MOD 2- Landscape responses

PROJECT Hammondcare Greenwich
PROJECT NO 19-165s
DATE 15.06.2026

The following are the Landscape Consultants responses to the RFI's raised by DPHI / Council's review of the Modification 2 submission with regards to additional information and clarification.

Figure 5 Current Mod 2- Typical layout- GRC planter replace in built planter REVISION E

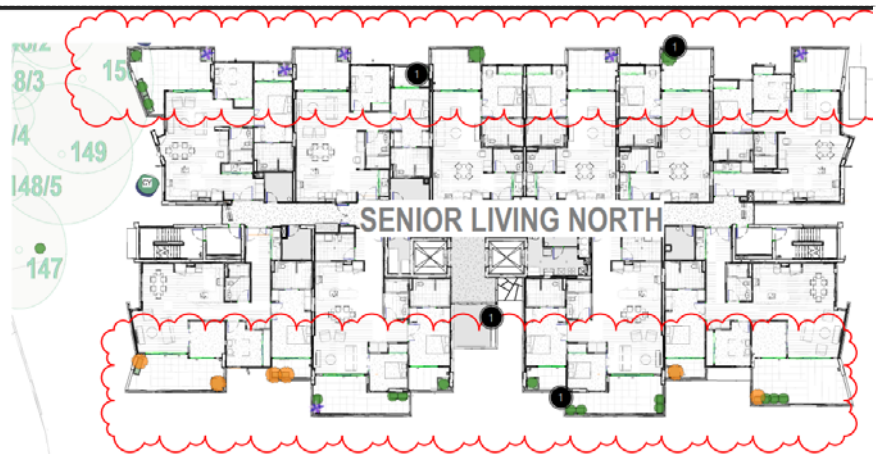
- b) The planters on the apartment terraces of the Seniors Living building's, have been substituted with GRC planter boxes. This change responds to issues identified during the Detail Design phase and takes into consideration buildability input, water proofing detailing and the construction program. Items resolved include waterproofing, drainage and appropriate separation between planter media and the slab. GRC planter sizes were selected based on size and market availability, with minor changes to the soil volume. (Refer to LA-SL-203 [E], LA-SL-204 [E]) We note that the south-western planter at the Seniors Living North building, closest to the adjoining residential properties, will remain as a raised planter that supports screening vegetation as is required by the SSDA. (Refer to LA-SL-203 [F], LA-SL-204 [F])

Planters that were isolated and maintenance access is difficult, have been removed. Privacy and screening issues between the Seniors living north and Seniors living south are unaffected as the distance between the terraces exceeds 15metres.

Figure 10 Mod2- removal of boardwalk

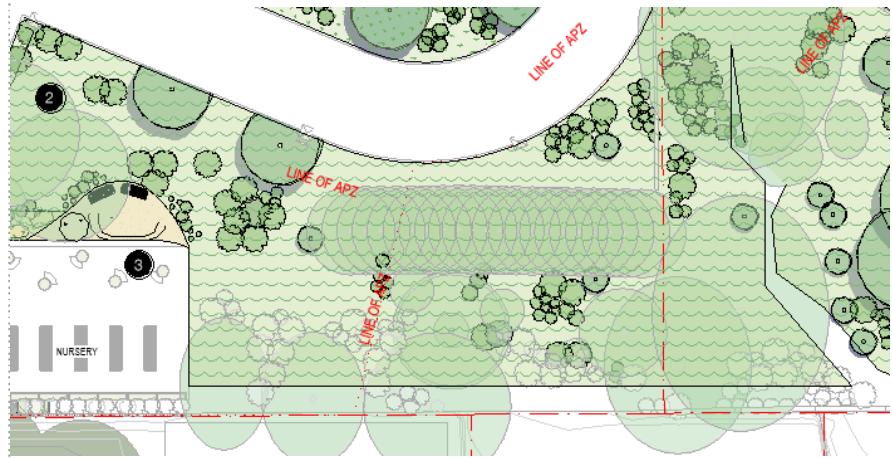
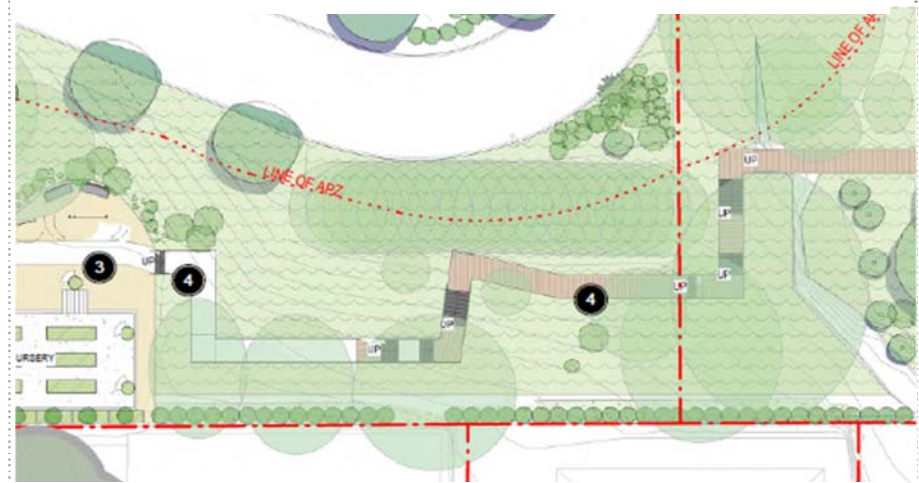
- a) Removal of the landscape boardwalk element following detailed design development and rationalisation.
The path and boardwalk that connected the main entry of Pallister house to the plant nursery area, in the southwest corner of the site has been removed. Safety concerns in the stepped sections and the nursery connection end of the boardwalk, being in un-observed areas, was seen to be a high risk option, where alternative paths of access to the Plant Nursery, along accessible and equitable paths, in passively observed areas, are available.

Figure 11, Mod2- carpark bay

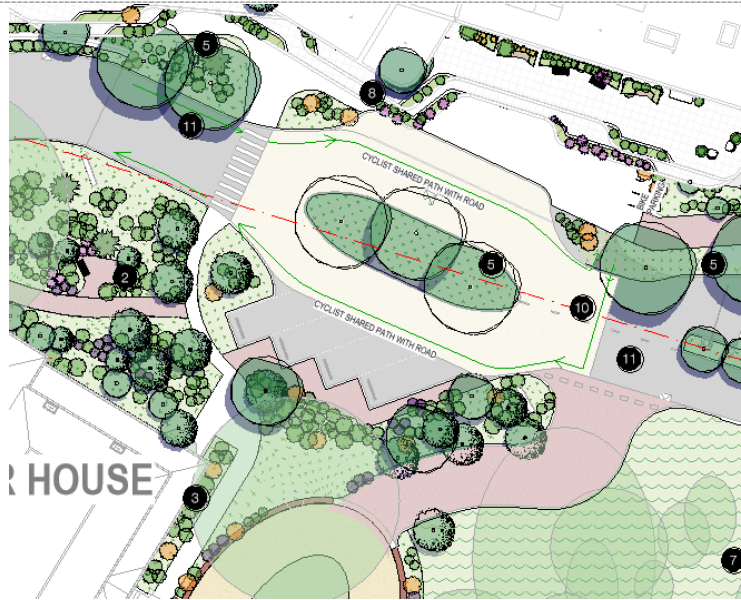
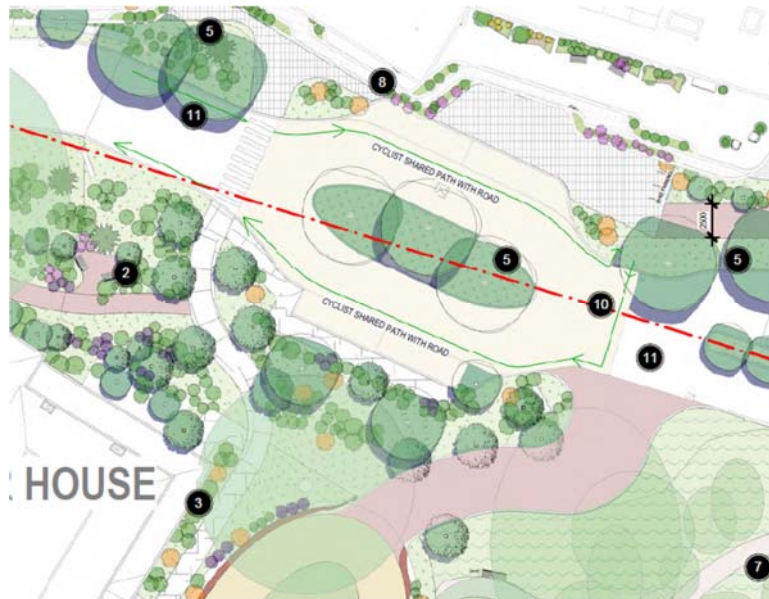
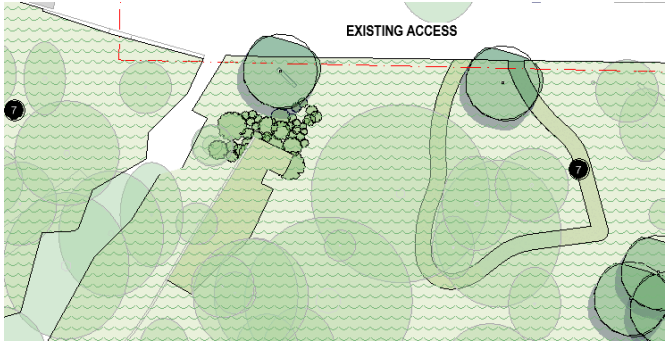
- b) The relocation of carpark bays to the level 4 (on grade) Drop off area between the Health and Care building and Pallister House, has resulted in minor adjustments to the landscape layouts to accommodate four car spaces adjacent to the turning area.

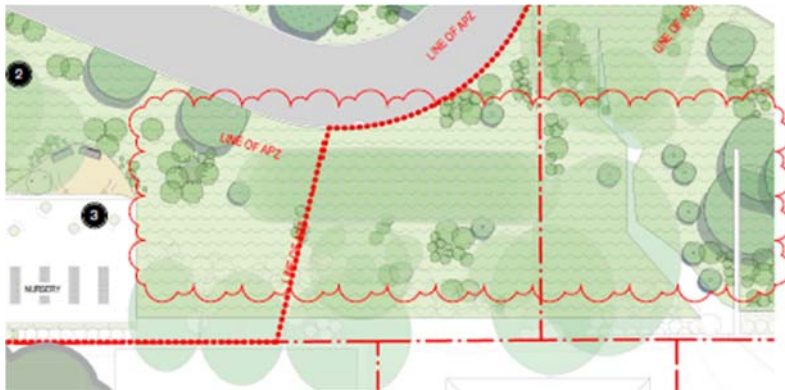
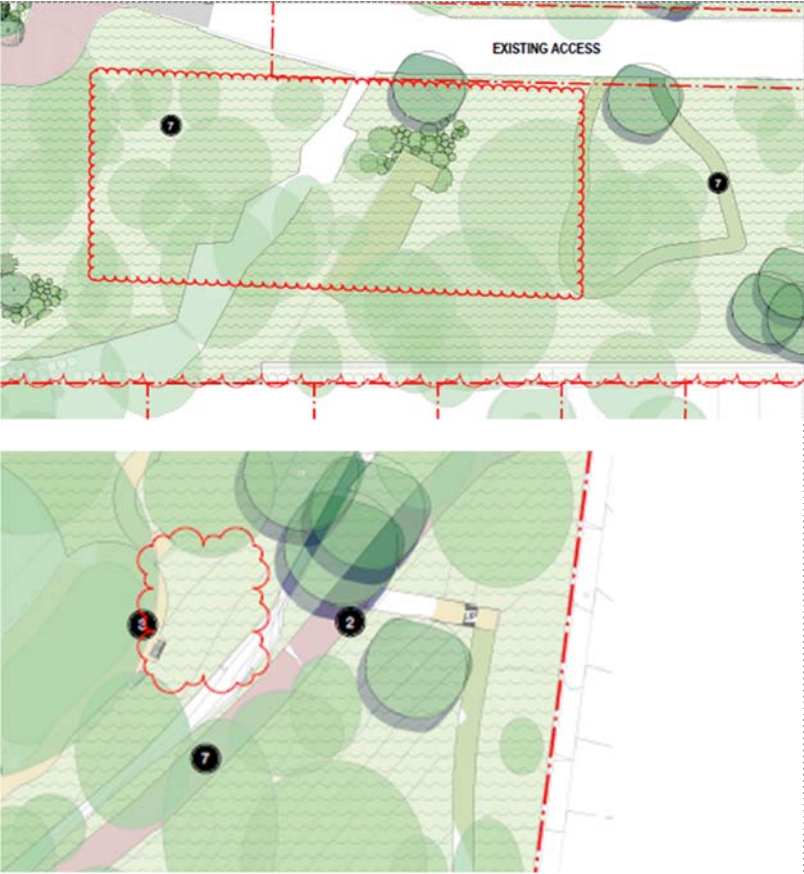
2.0 **Provide further details of the exact proposed changes to the boardwalks and any anticipated impacts on**

Removal of landscape boardwalk element following detail design and rationalization's as below:

The landscape boardwalk element that ascended the southeast corner of the site, traverses through an ecologically sensitive area. Existing indigenous tree species, habitat and significant sandstone

vegetation and ecology. outcrop's and overhangs of potential geological and Indigenous significance to the site, populate the area. The modified landscape design, proposes to remove the built boardwalk element and replace it with a low-impact pedestrian loop path (mown turf within seasonally maintained grasses). This will establish a similar experience through the easier to access, natural features, at existing grades. The removal of the fabricated sections will considerably reduce the impact associated to installation and construction activities of the boardwalk structure. This proposed change considerably reduces the risk, damage and exposure of the ecologically and potentially archaeologically significant elements.  <i>Figure 13 MOD2 removal of boardwalk</i>  <i>Figure 14 Stamped SSDA stairs and boardwalk layout</i> Nesting boxes have been installed to support local fauna and provide safe nesting places and reduce the effects of disturbance due to construction activity on adjoining areas of the site. The path and boardwalk connection between Pallister House and the plant nursery has been discussed 1.3a. Alternative ways of accessing areas such as the Plant Nursery are provided using accessibility and equitable path network through passively observed areas of the site. These alternatives paths of travel remove the path along the south boundary that is largely unobserved.
